UNITED STATES PATENT AND TRADEMARK OFFICE

APPLICATION NO.	FILING DATE	FIRST NAMED INVENTOR	ATTORNEY DOCKET NO.	CONFIRMATION NO.
10/568,740	02/17/2006	Takahisa Sato	F-9000	4933
28107 7590 03/21/2007 JORDAN AND HAMBURG LLP 122 EAST 42ND STREET SUITE 4000 NEW YORK, NY 10168			EXAMINER KIKNADZE, IRAKLI	
			ART UNIT 2882	PAPER NUMBER
SHORTENED STATUTORY PERIOD OF RESPONSE			MAIL DATE	DELIVERY MODE
3 MONTHS			03/21/2007	PAPER

Office Action Summary

DETAILED ACTION

FIG. 1

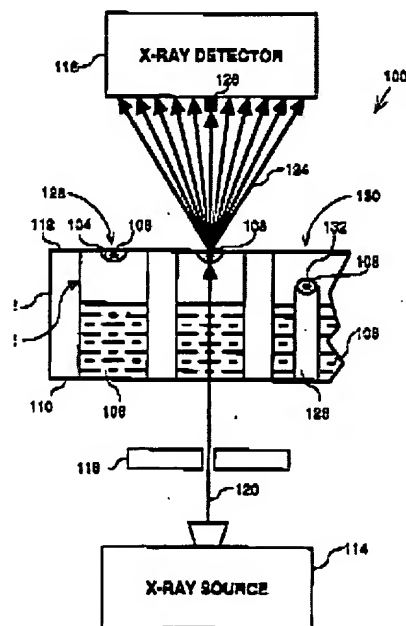
With respect to claim 1, Newman teaches an apparatus (100) for using a sample container (102) through which X-ray, ultraviolet light and visible light are transmissible

crystal (108) existing in the sample container is characterized by comprising (Figs. 1

With respect to claim 3, Newman teaches that the X-ray measuring stage comprises: X-ray irradiating means (114) for irradiating X-ray from the upper side or

lower side to the specific macromolecule crystal in the sample container disposed in the sample disposing portion (Fig.1; paragraph 0040); X-ray detecting means (116) that is disposed so as to confront the X-ray irradiating means through the sample container (102), and detects diffracted X-ray from the specific macromolecule crystal transmitted through the sample container (Fig.1; see paragraph 0047, lines 7-12 and paragraph 0049). Further, Newman teaches that positions of the x-ray irradiating means (114) and the x-ray detecting means (116) may be switched (see paragraph 0040, lines 4-8) but fails to teach a rotary arm for supporting the X-ray irradiating means and the X-ray detecting means with an associated driving mechanism.

FIG. 2

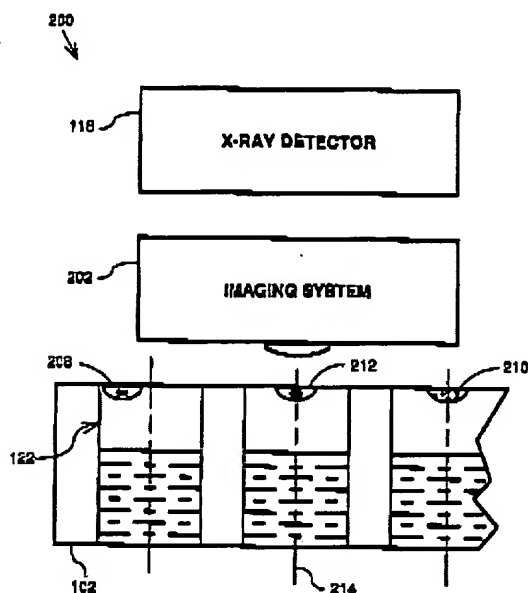
a sample detecting stage associated with imaging system (202) for detecting the specific macromolecule crystal in the sample container (Fig. 2; paragraph 0054);

with an x-ray source (114) and an x-ray detector (116); see Figs. 1 and 2) that is disposed so as to be spaced from the sample detecting stage and carries out an X-ray diffraction measurement of the specific macromolecule crystal (see paragraphs 0037; 0040; 0046, lines 7-12 and paragraph 0049);
